PRODUCT CHANGE NOTIFICATION

#PCN-DCT-3CW6-10

Business Unit	Product Line Code	Type of Change	Action	Date of issue
DCT	205	Aesthetic	Notify Distributors and Field	07/07/2010

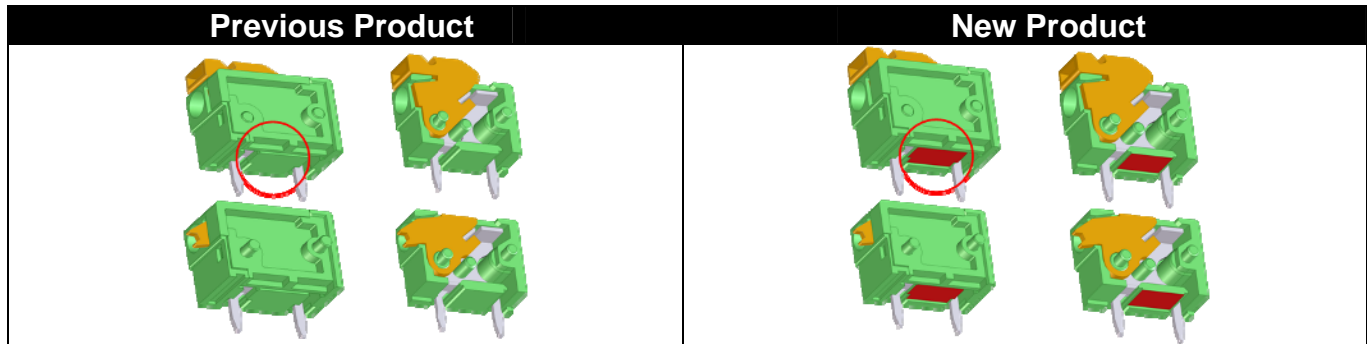
To improve the following FKDS terminal block products, they will now be made with a recess on the bottom of the block. In addition the wall will become thinner between the solder pins. All dimensions and technical data will remain the same.
